CITY OF TACOMA

ADDENDUM NO. 2

DATE: November 12, 2019

**Request for Bids Specification No. PW19-0306F
TACOMA FIRE STATION #5**

C2-0

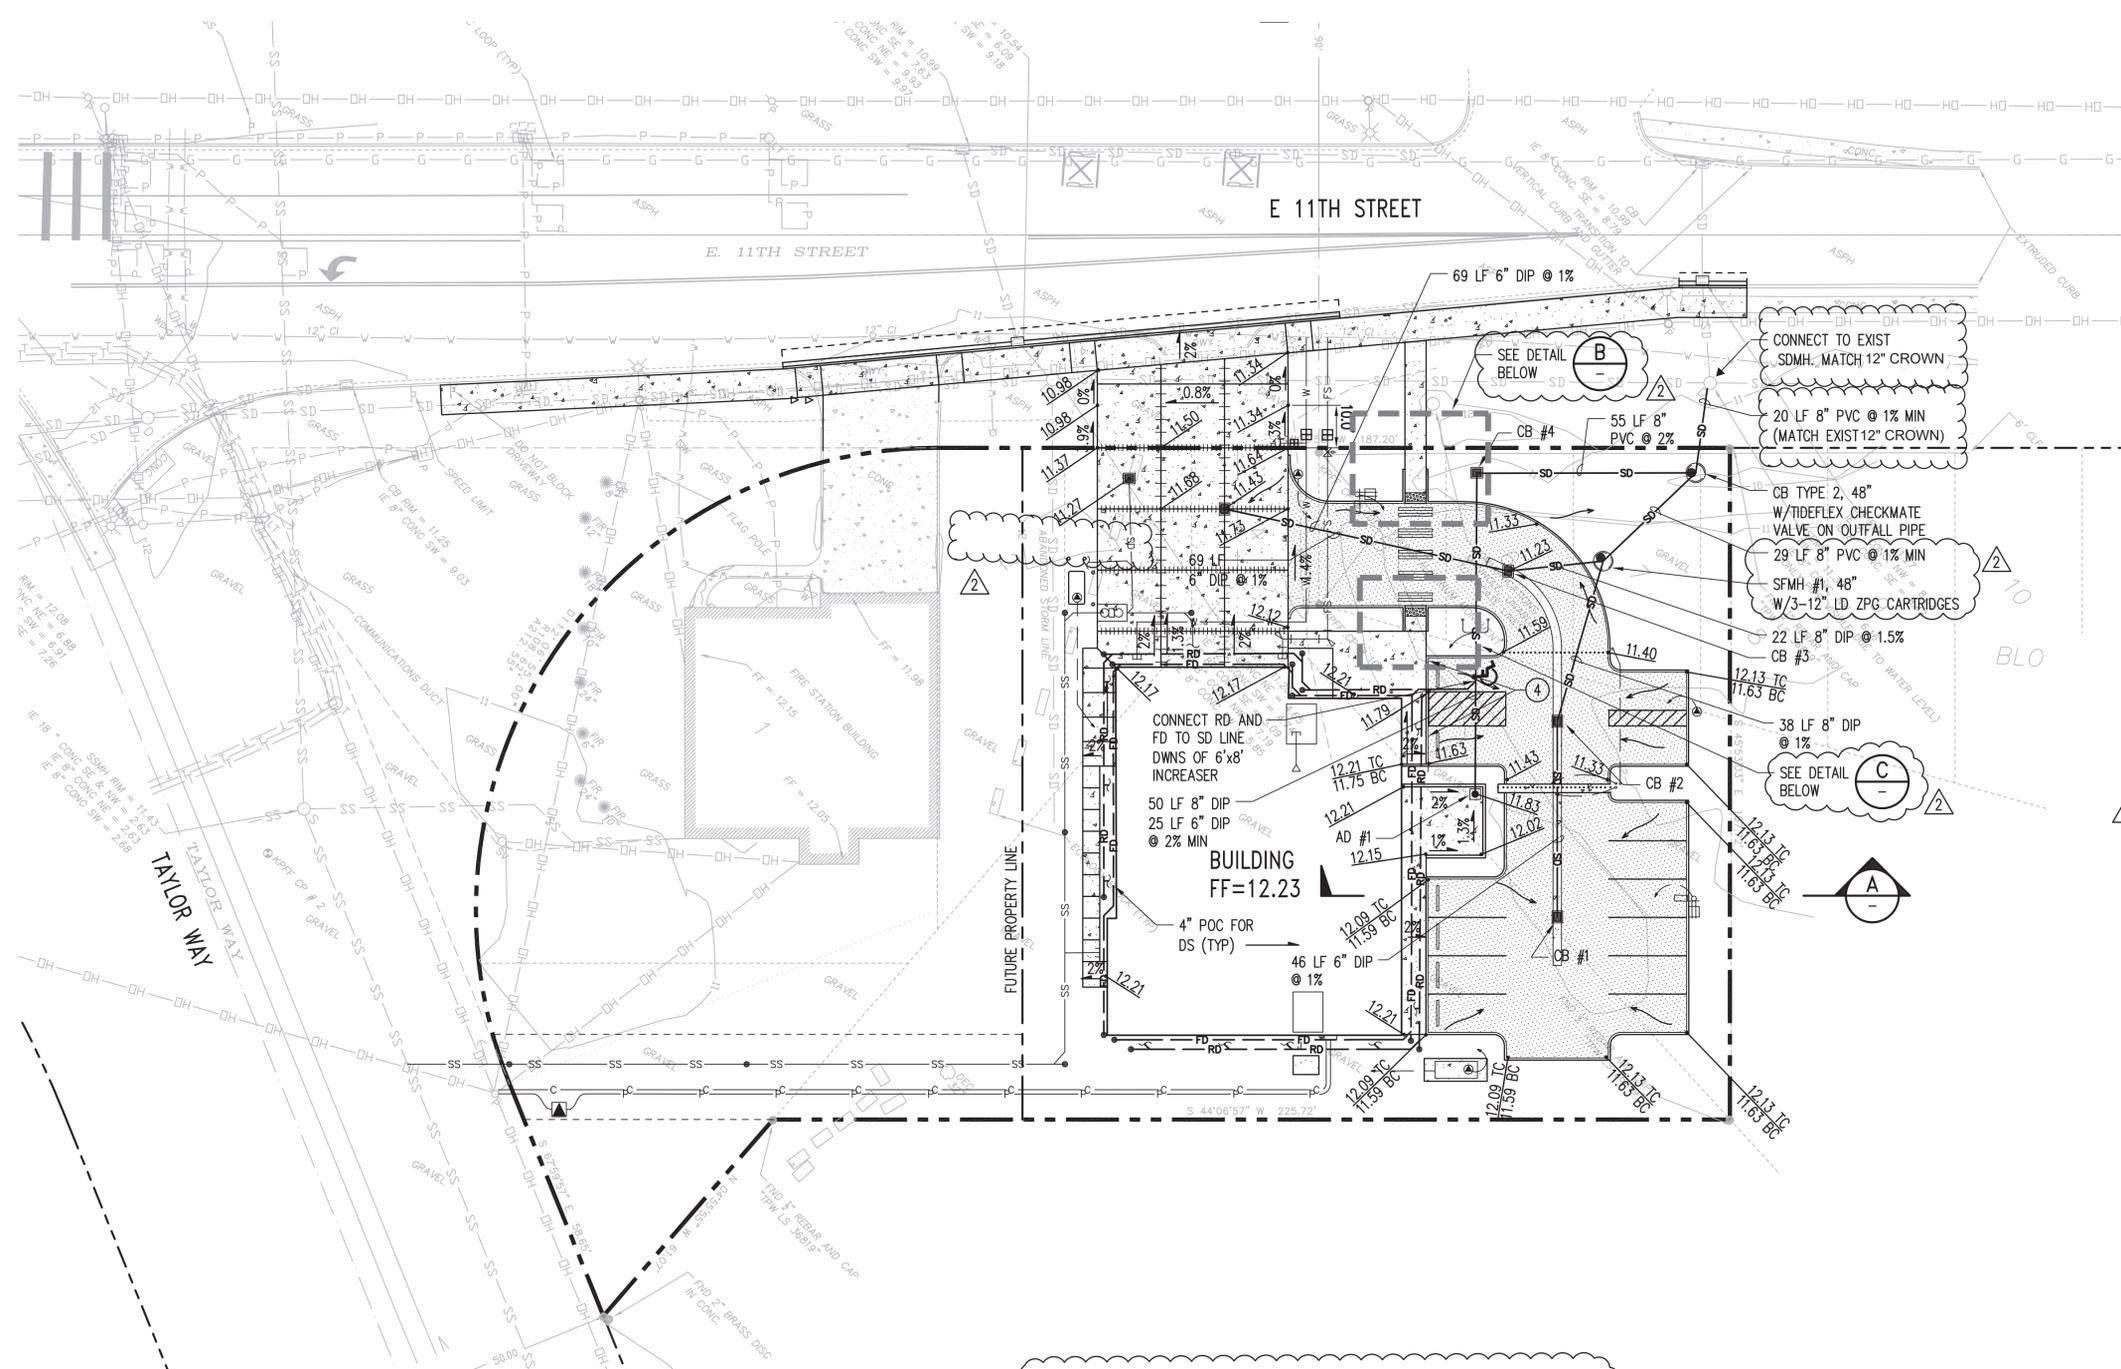
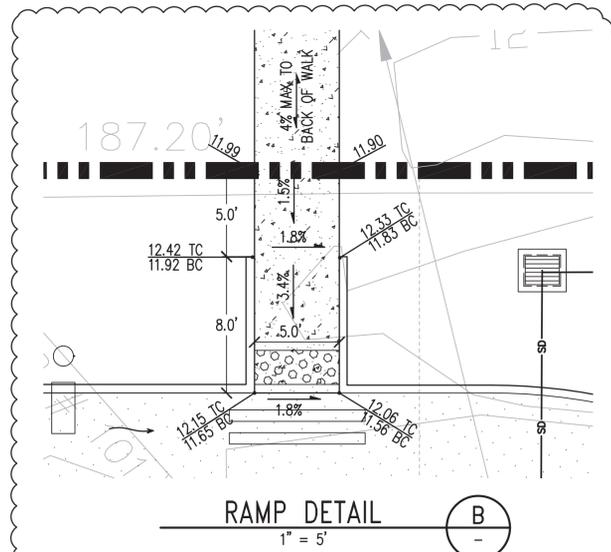
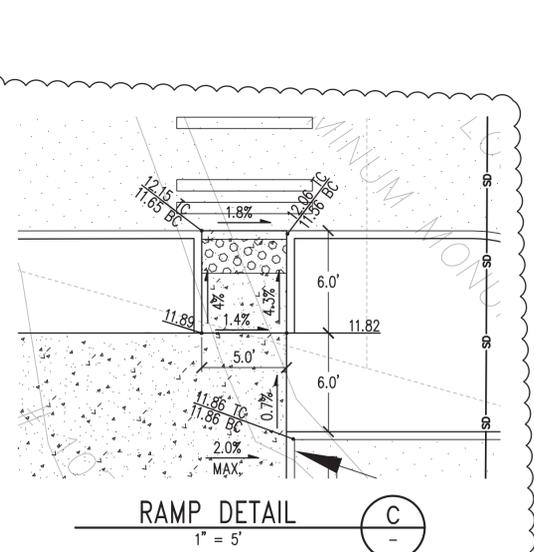
SHEET C2-0 GRADING & DRAINAGE PLAN (as shown on re-issued sheet C2-0, and identified as Addendum 2 in the revision portion of the title block)

REVISE: SFMH #1

DELETE: 8" PVC note on driveway

ADD: Note 4 regarding slope

ADD: Details B&C Ramp Details

Question 5: Sheet C2-0 shows an 8” PVC line going from a catch basin to a vault. Sht C3-0 shows it as 30 lf of 6” PVC. Please clarify.

Answer: Use Sheet C3-0 for correct size. Sheet C2-0 has been revised to remove extra label.

PHASE: _____
 Bid Set
 JOB NO.: 1900060
 DATE: 9.24.19
 SHEET TITLE: UTILITY PLAN
 SHEET NO.: C3-0

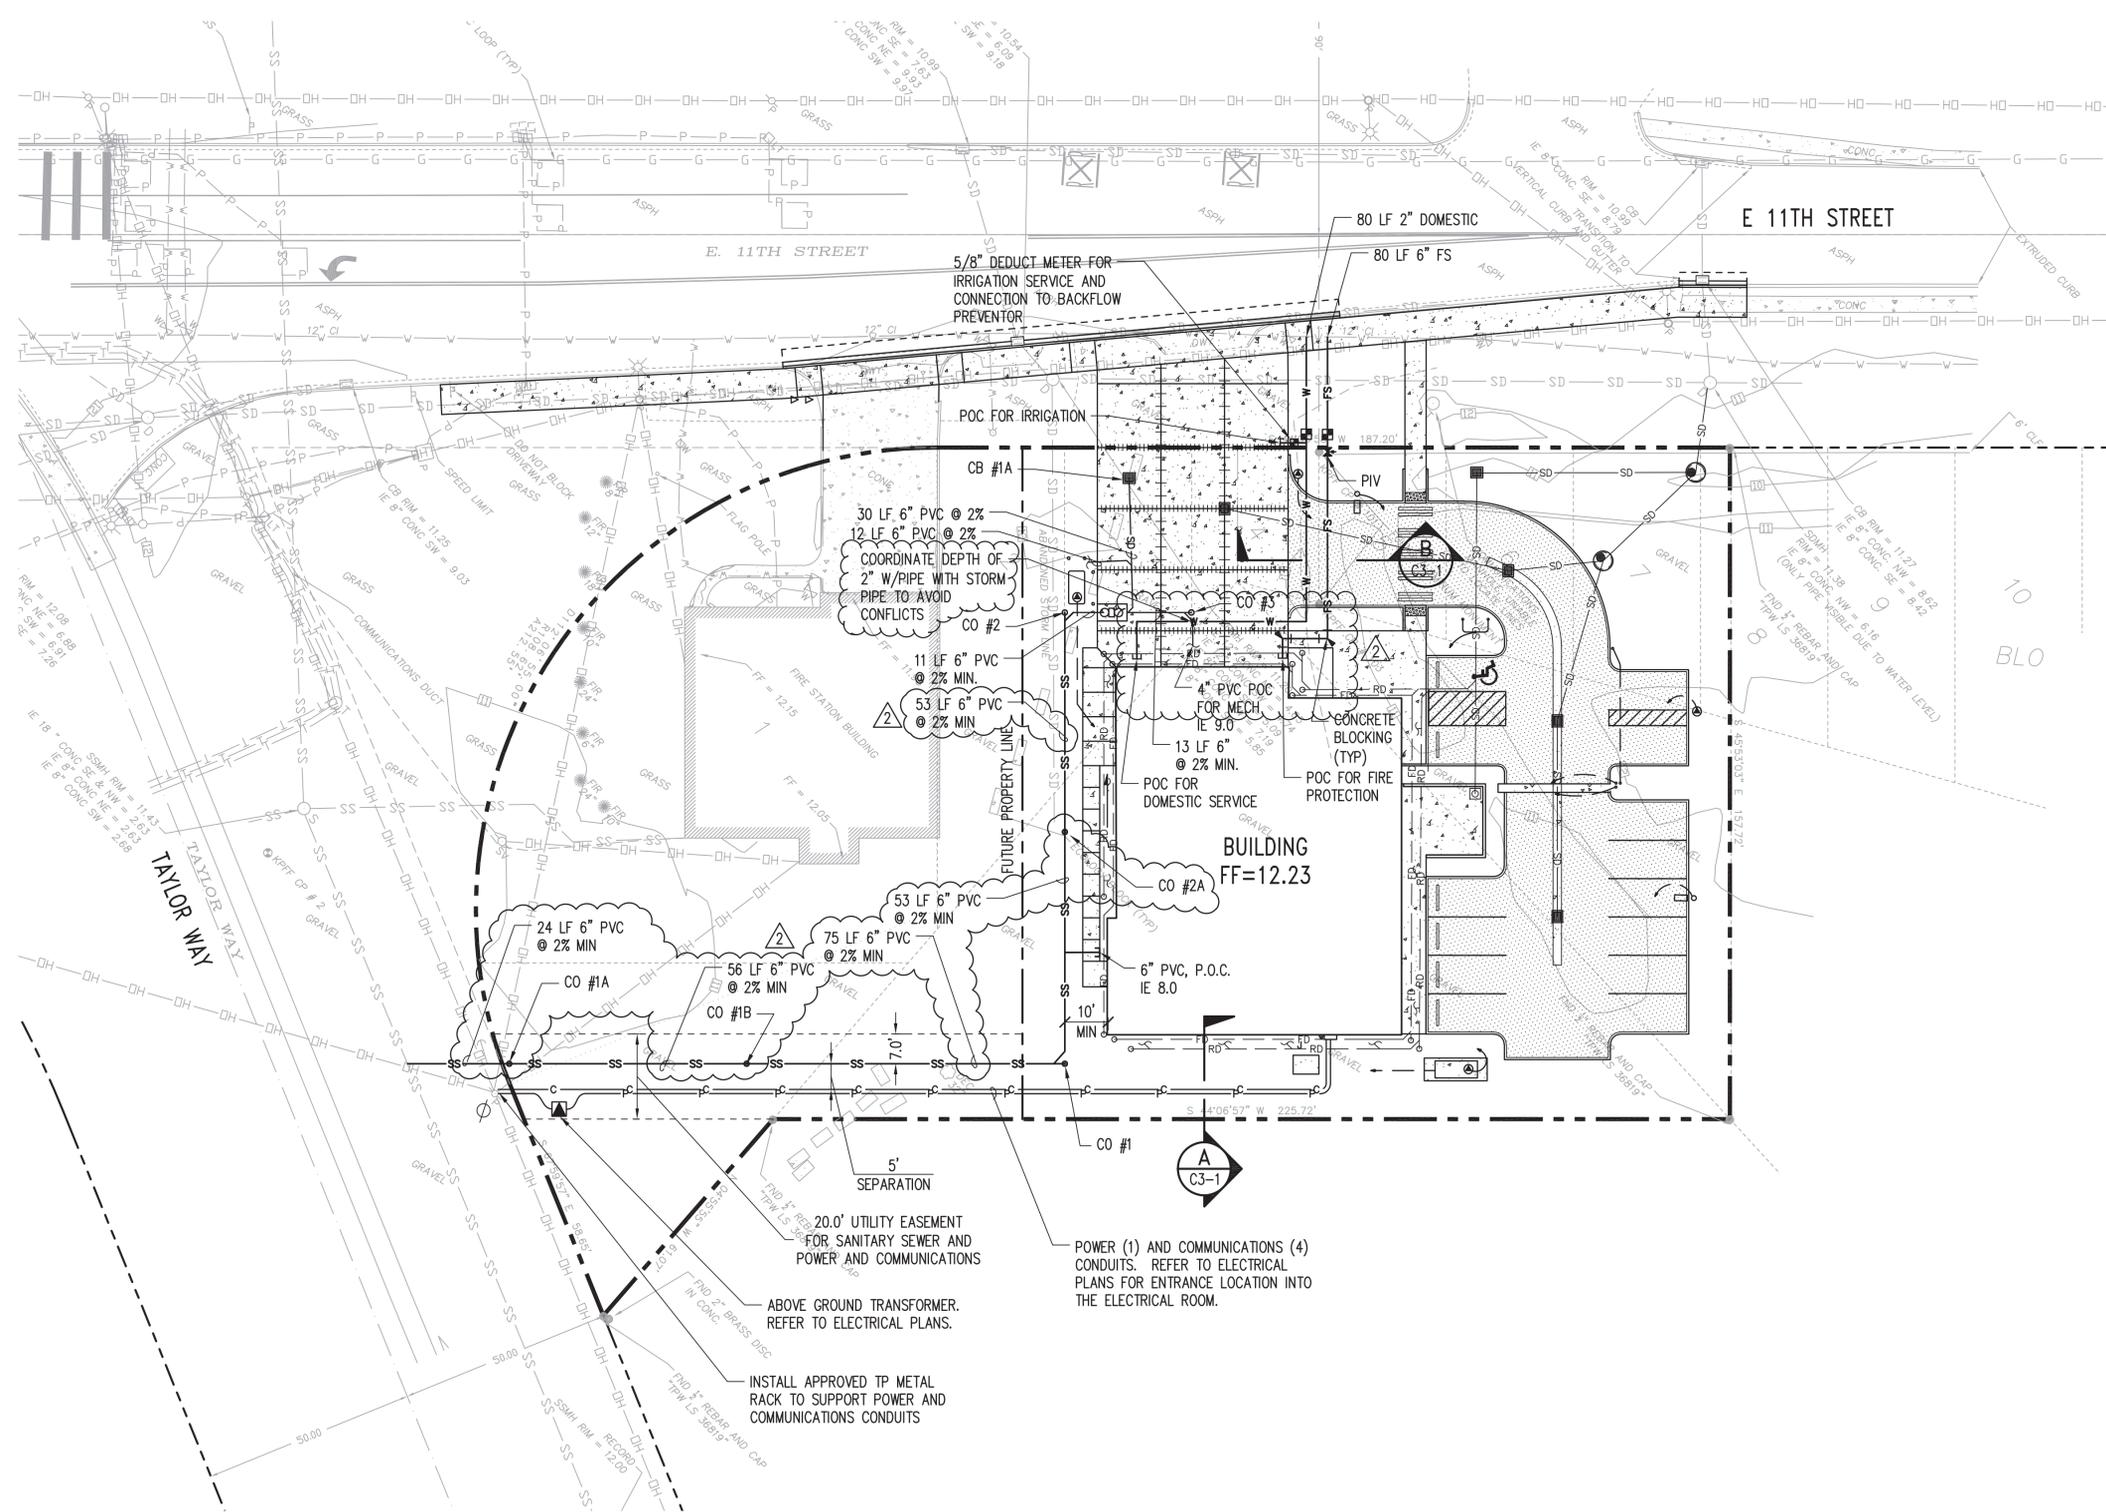
SHEET C3-0 UTILITY PLAN (as shown on re-issued sheet C3-0, and identified as Addendum 2 in the revision portion of the title block)

ADD: (3) Sanitary Sewer Cleanouts

REVISE: Domestic Service POC location

ACCESSIBLE PARKING STALL DETAIL
NTS

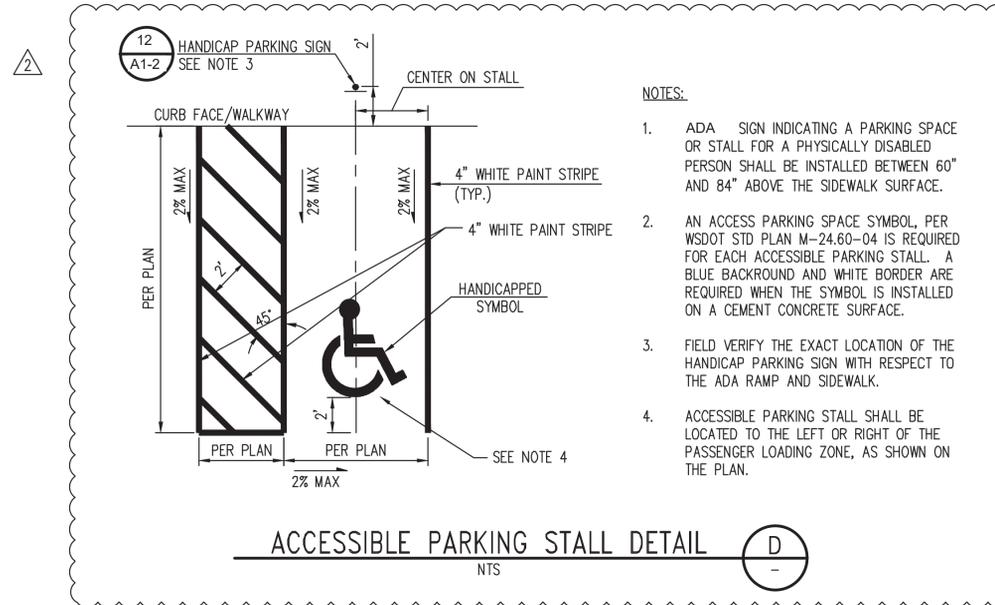
ADD: Note to read "2% max slope" to the Accessible Parking Stall Detail

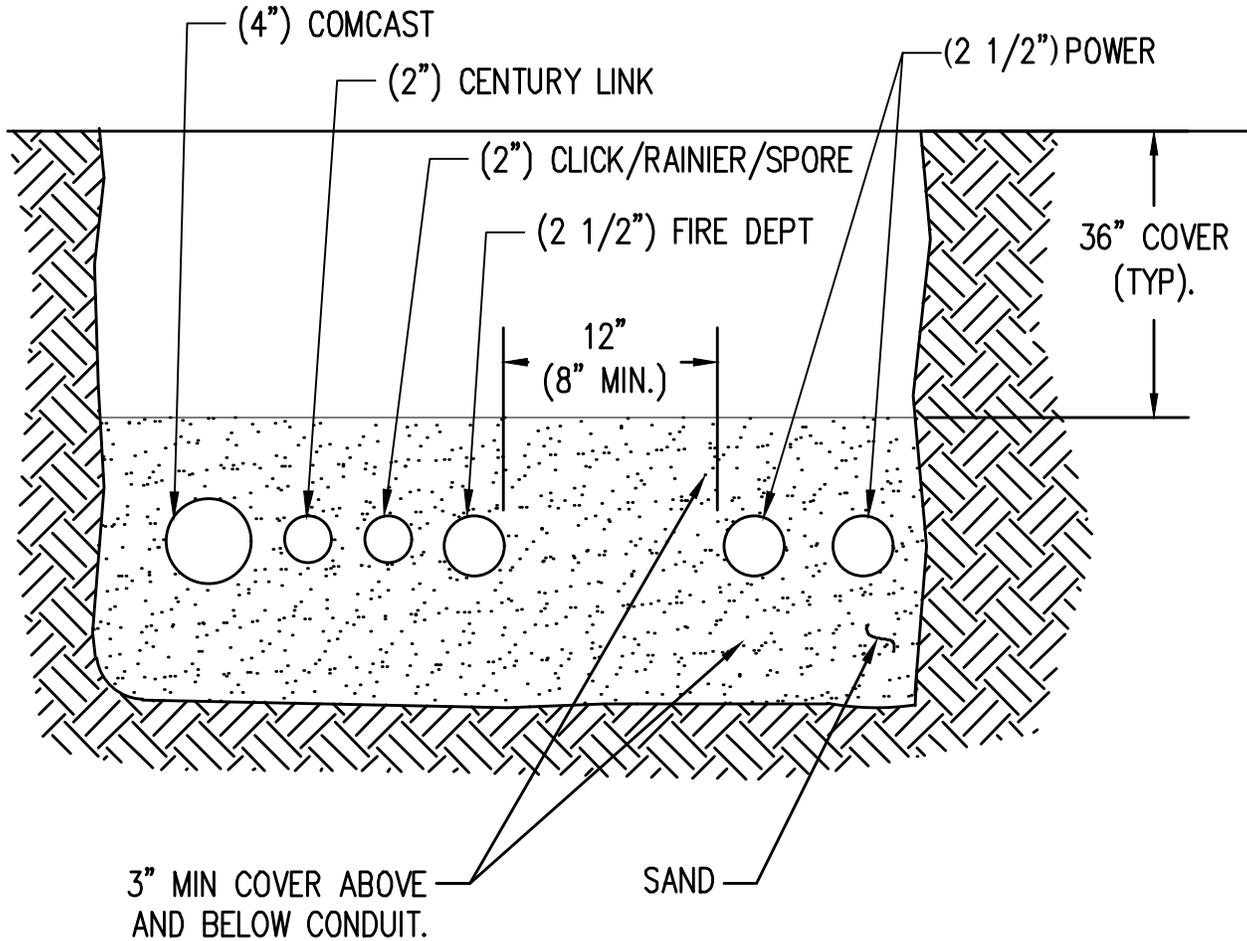
SHEET C3-1 UTILITY DETAILS

REVISE: Detail A Power & Comm as shown on Addendum drawing CSK-02.
